21 October 2016

Project: Re-Roof Natchez Academic Center
Copiah-Lincoln Community College
Natchez Campus

Addendum No. 1

PARTIAL FLOOR PLAN - PART A - HVAC
SCALE: 1/8" = 1'-0"

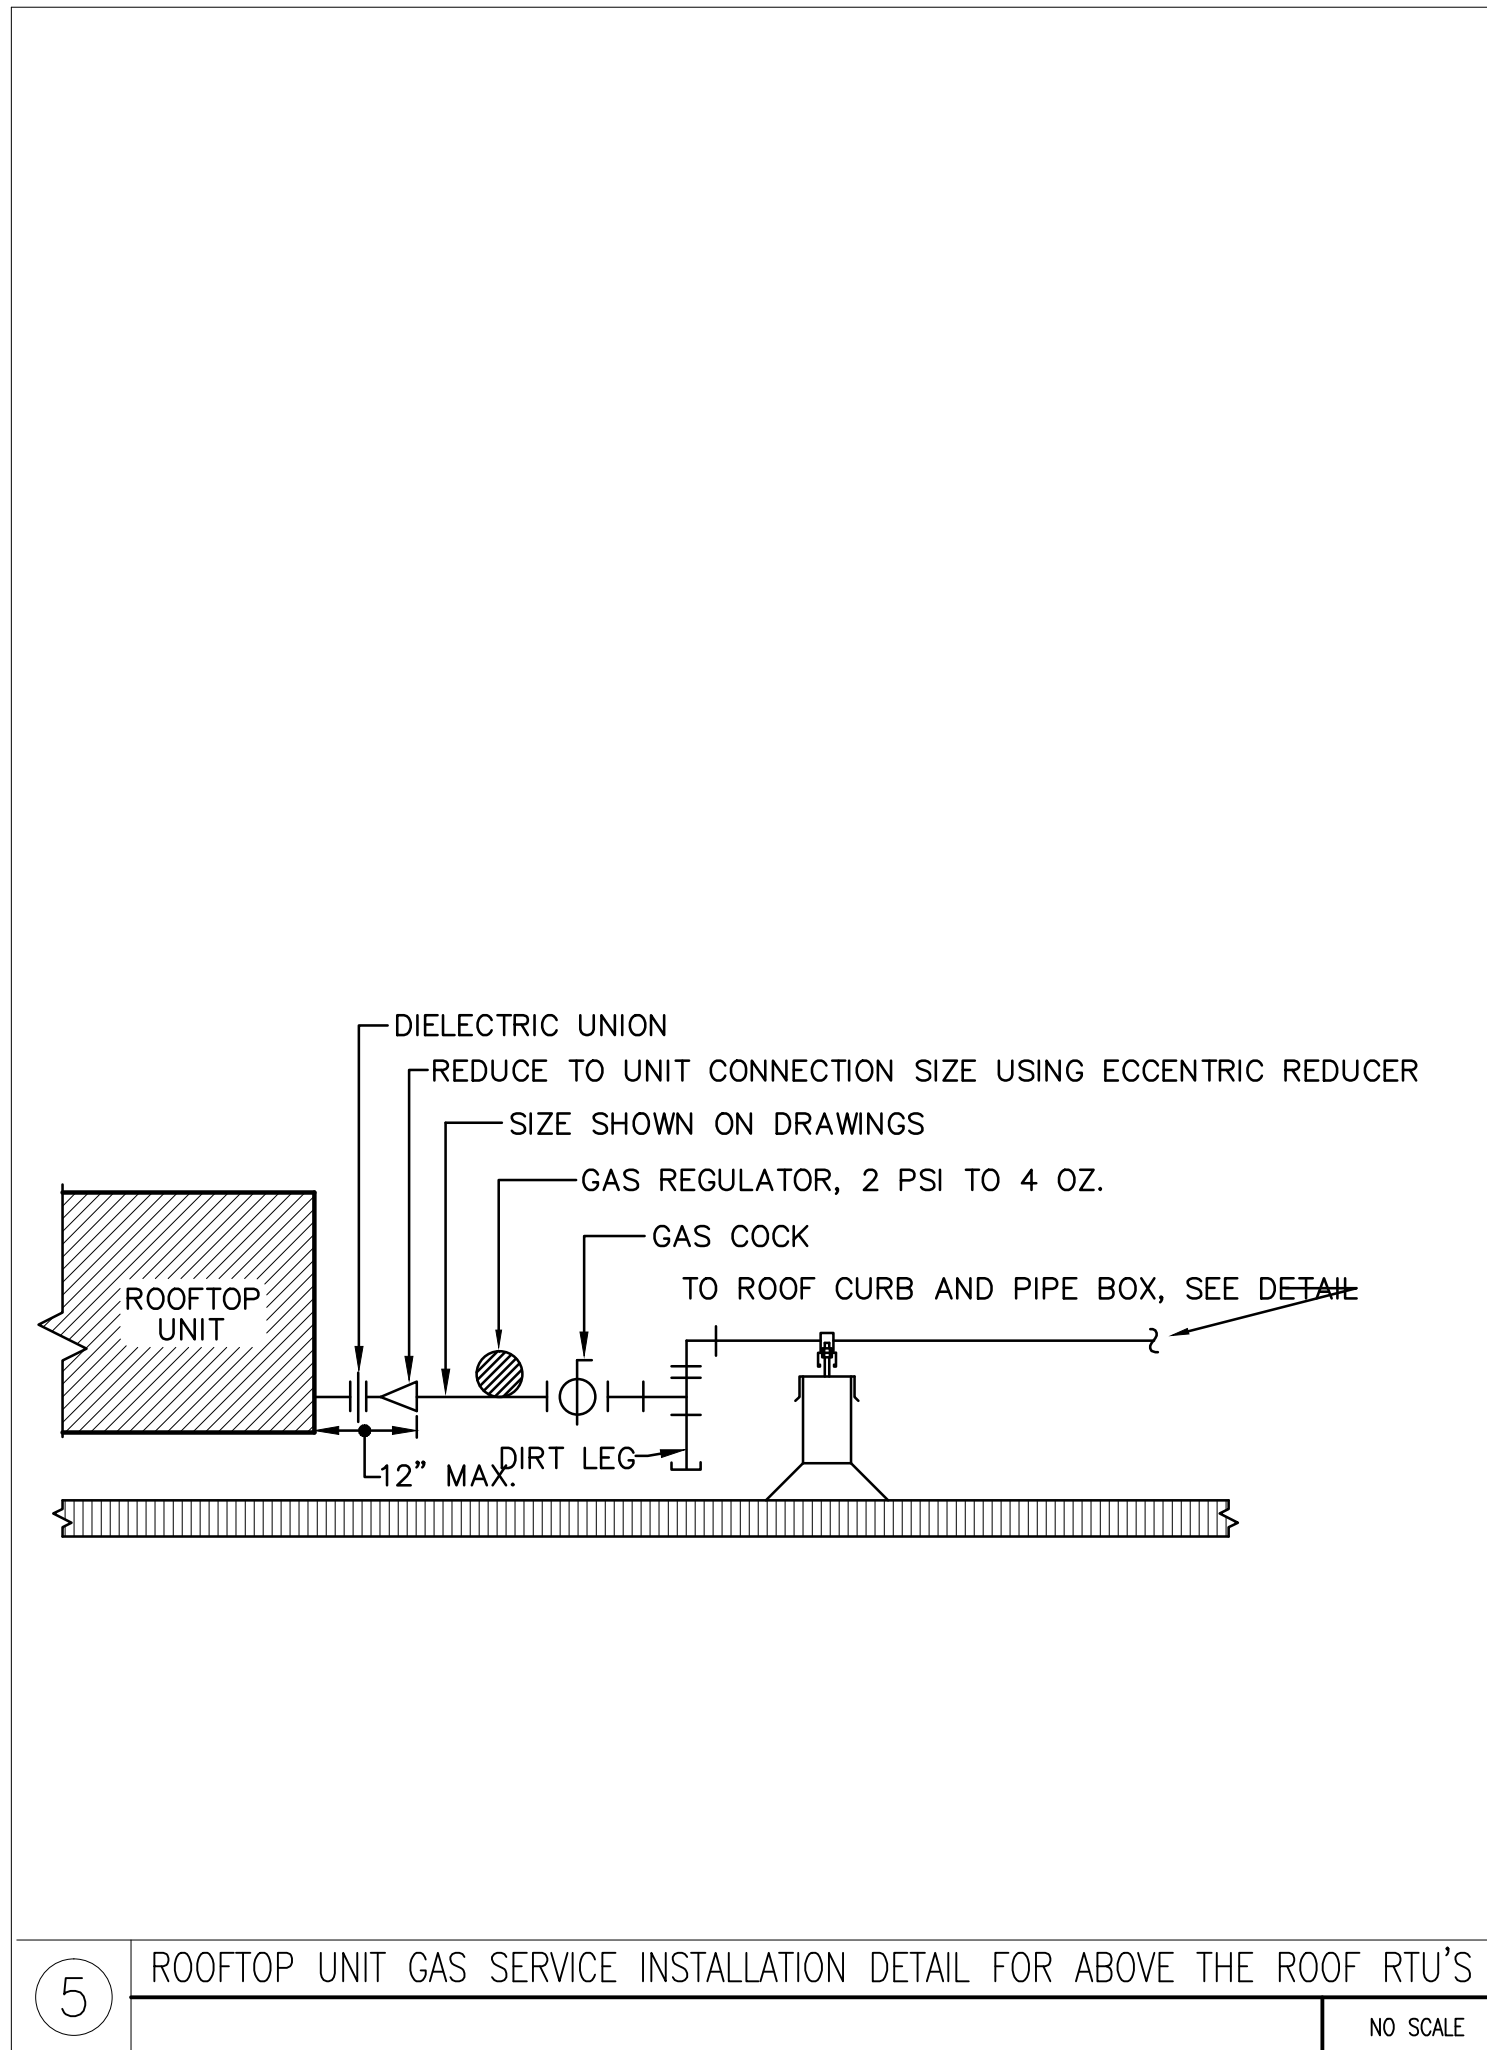
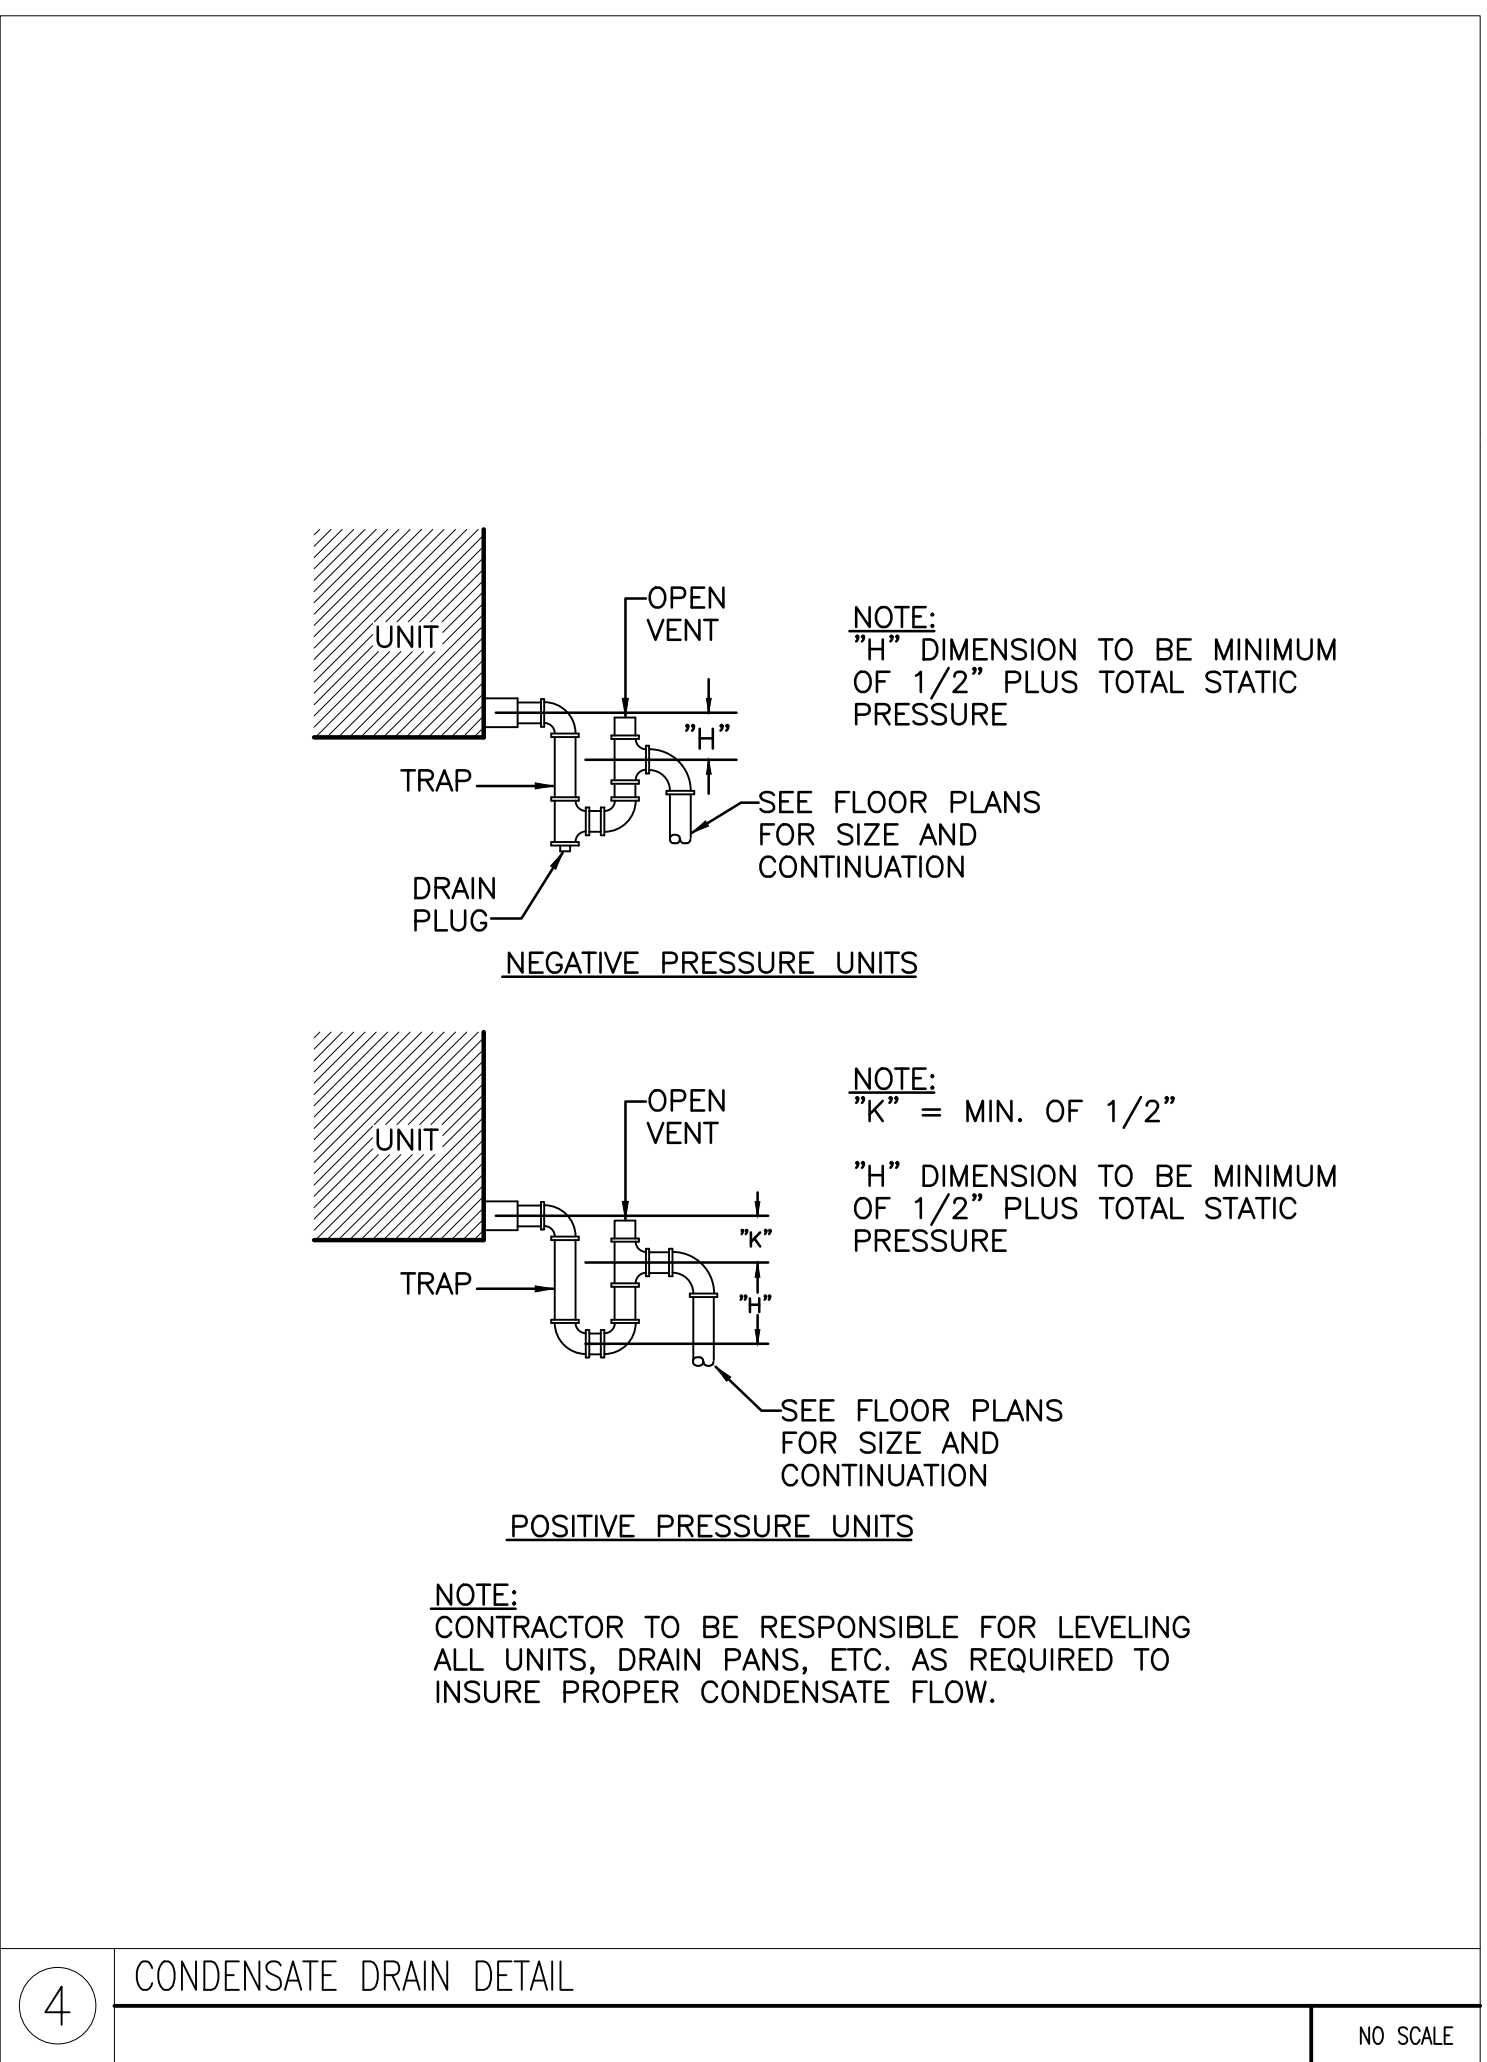
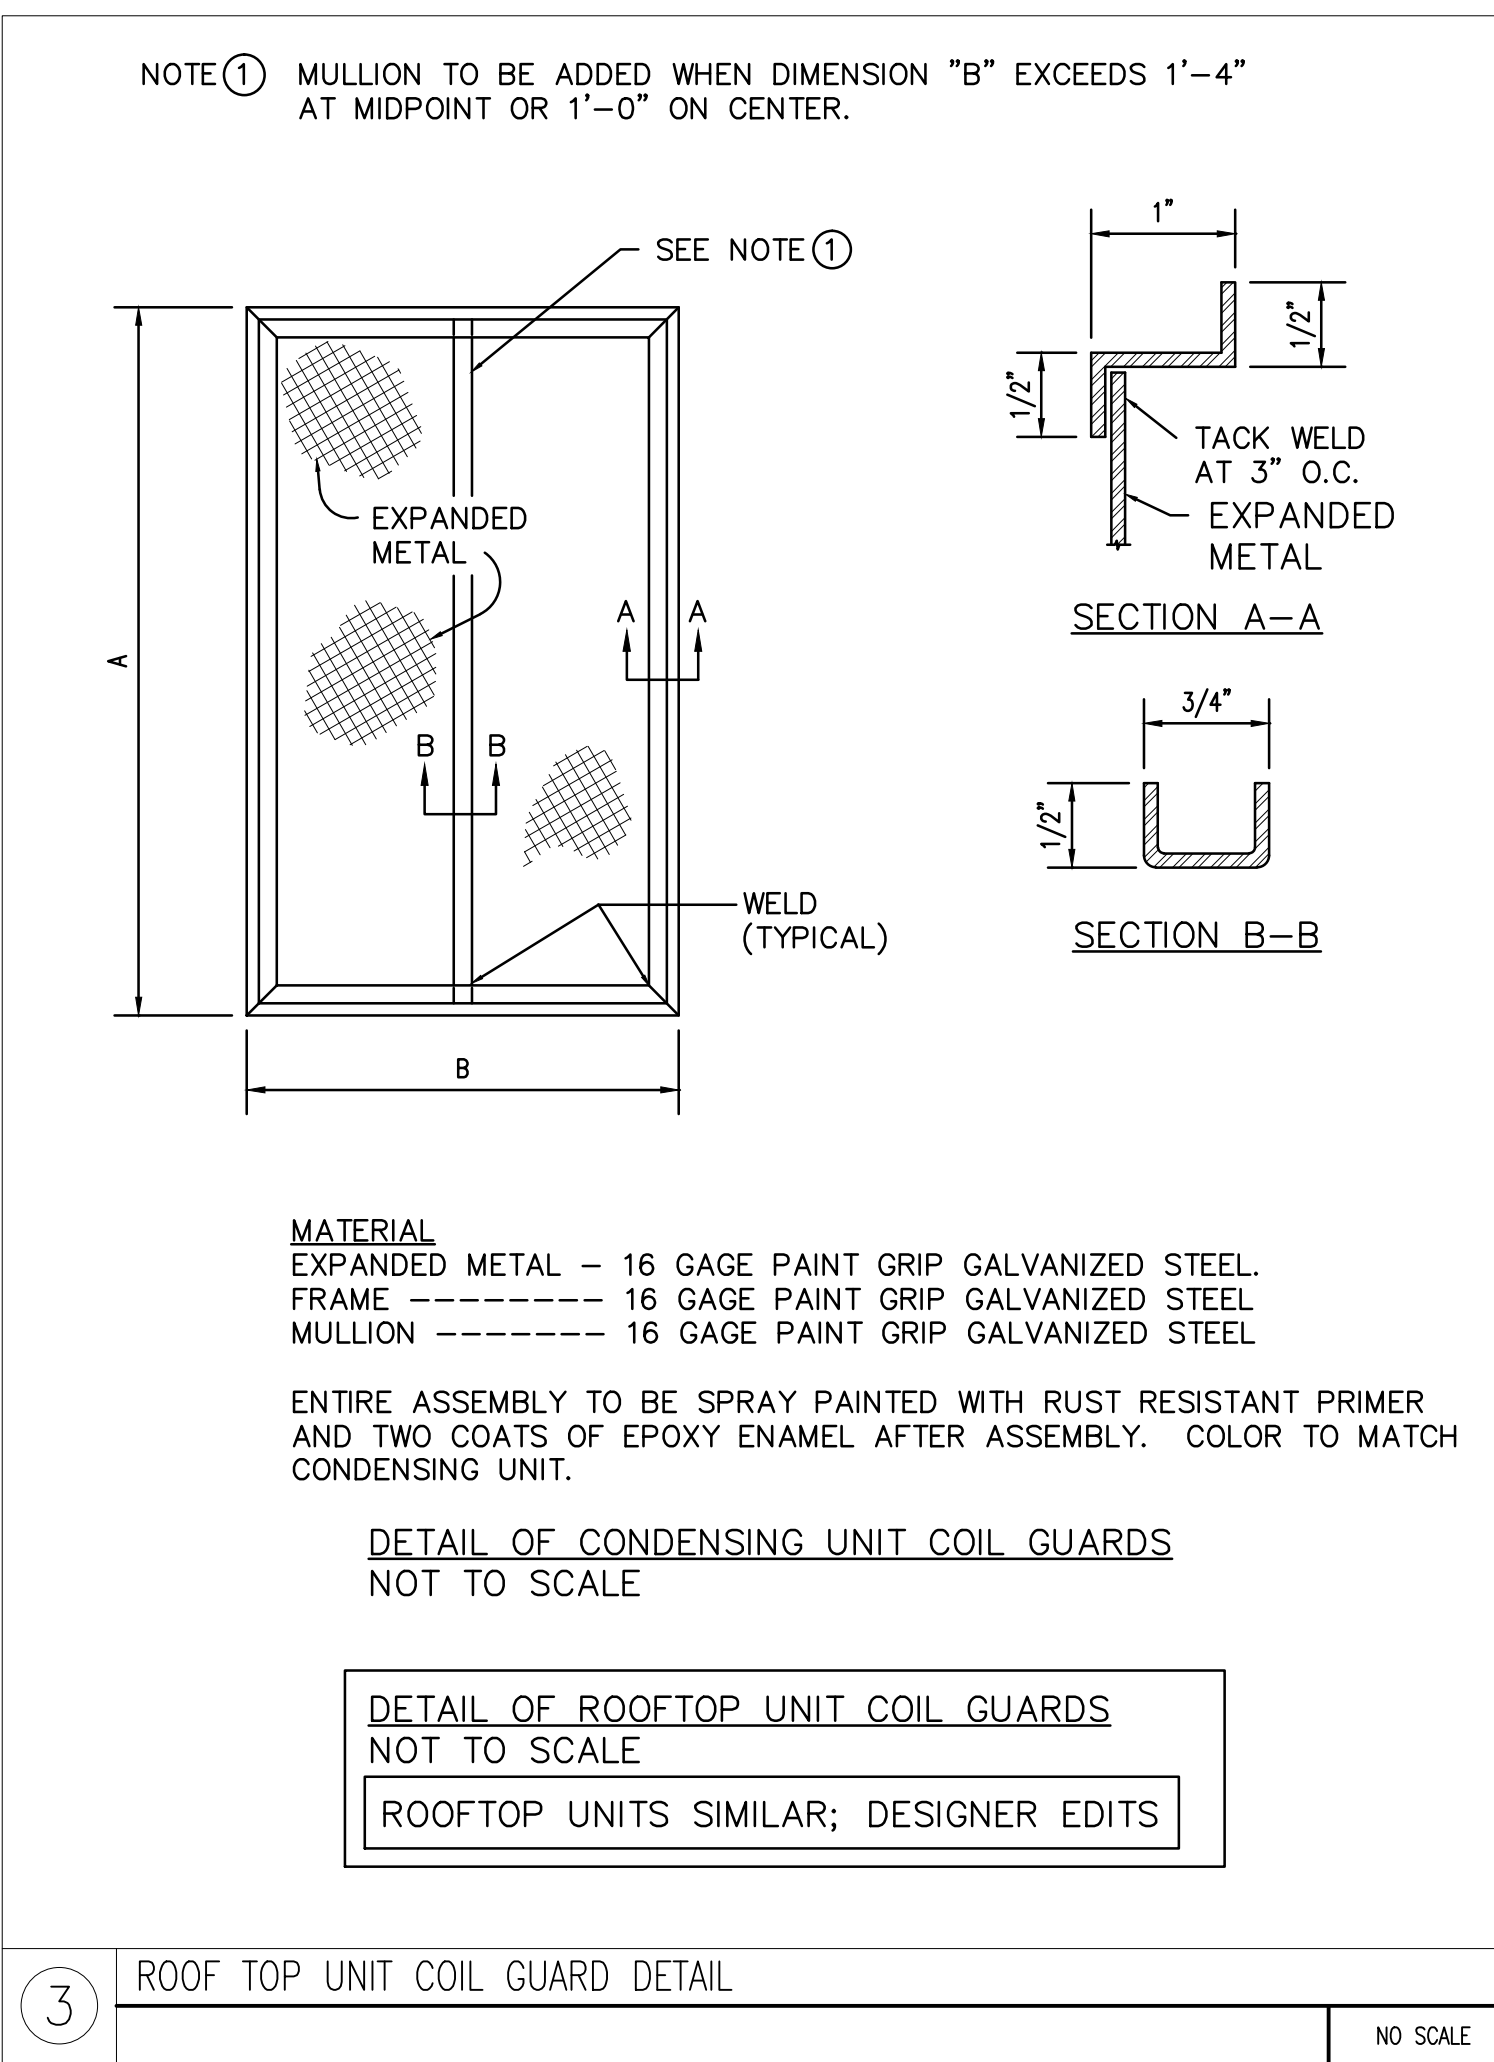
11) Sheet M105

The attached sheet M105 is revised to reflect natural gas piping above Library & Main Entrance areas routed on top of finished roof.
